KUD 2022-08 19.04.2022

Citymaster 650

New oil drain valve for Yanmar engine

Citymaster 650 1470.15

Appendix: Documentation on the change

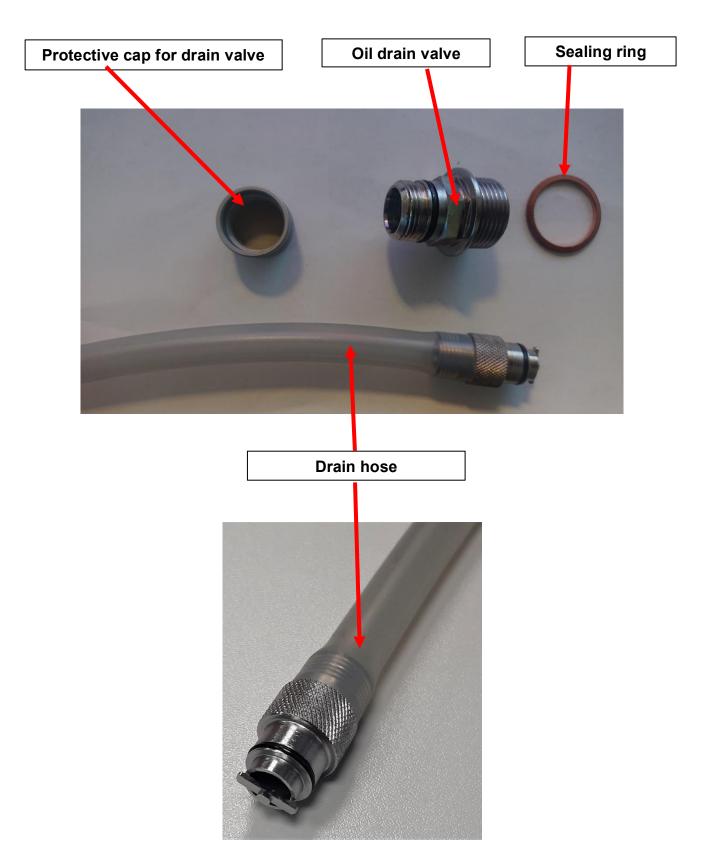
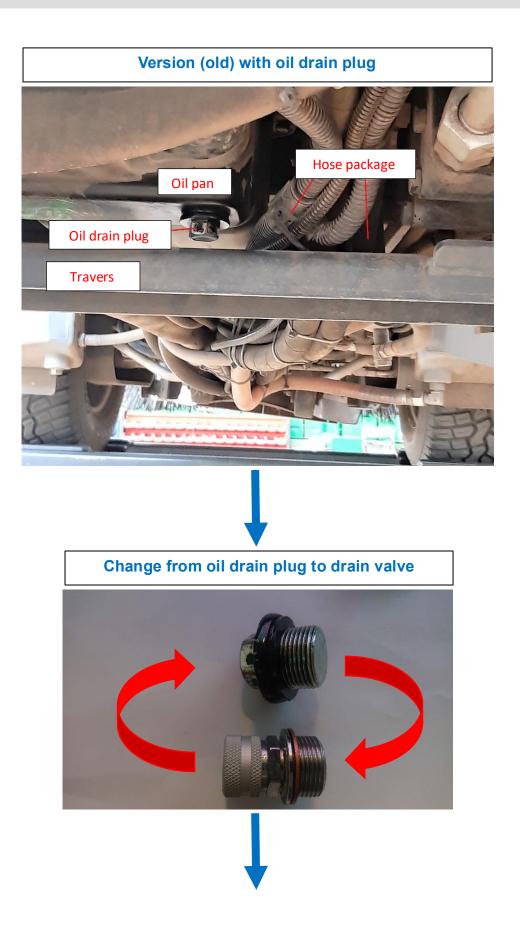
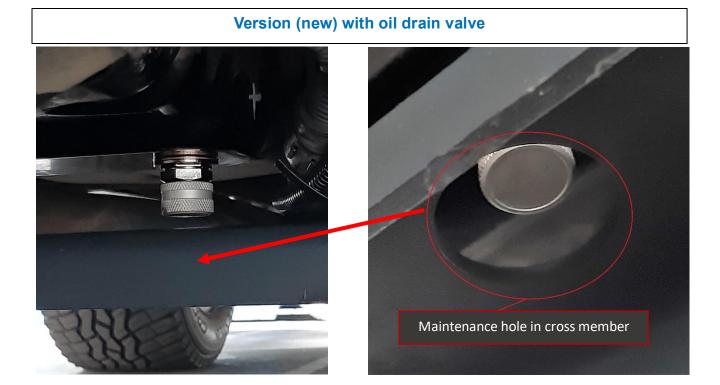
from now on, instead of an oil drain plug, an oil drain valve will be mounted from factory on the oil pan of the Yanmar engine (the drain hose is located in the vehicle in the tool bag (97124044)).

Vehicles with an oil drain plug can be retrofitted with the new oil drain valve. The set consists of a drain valve, a protective cap and a drain hose. It can be ordered at Hako under spare parts number: 01479580.
